Griffin Cove Transportation Consulting, PLLC

Subject: ***Proposed Trails at Carmel Mountain Ranch Project
Final Environmental Impact Report – San Diego, California***

As requested, Griffin Cove Transportation Consulting, PLLC (GCTC) has completed a review of the transportation/circulation analysis completed with respect to the proposed Trails at Carmel Mountain Ranch project (“Project”) in San Diego, California. The proposed project is the subject of a Final Environmental Impact Report (FEIR) prepared by the City of San Diego. (Reference: City of San Diego Development Services Department, *Final - Trails at Carmel Mountain Ranch Environmental Impact Report*, July 2021.) FEIR Section 5.2 presents the “Transportation/Circulation” analysis for the proposed project.

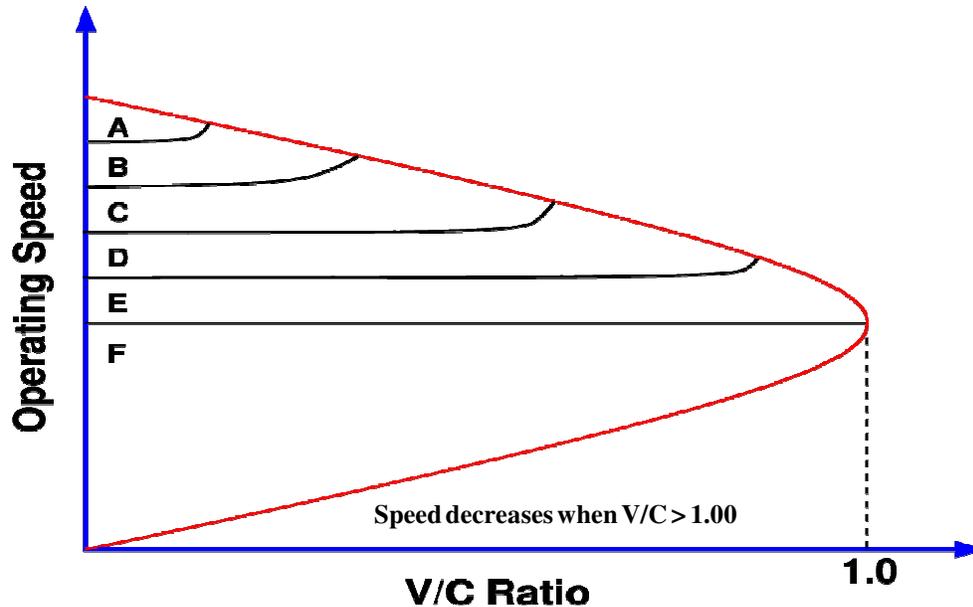
Unstable flow will be manifested in high levels of congestion and stop-and-go traffic, which will increase not only the time needed to evacuate, but also the levels of stress and anxiety for evacuees. The following graphic illustrates the relationship between LOS and travel speed. As shown, when a roadway reaches LOS F (i.e., V/C > 1.00), the operating speed rapidly declines.

Referring again to Table 6 – Project Evacuation Travel Timeframe (p. 36), we see that addition of the estimated 800 project-related vehicles to Ted Williams Parkway would increase the V/C ratio from 2.28 to 2.54, resulting in greater instability in traffic flow and further reduced travel speeds. This has not been accounted for in the analysis, even though the evacuation plan acknowledges the current and future existence of traffic congestion in the vicinity of the Project. Specifically, it says (p. 49):
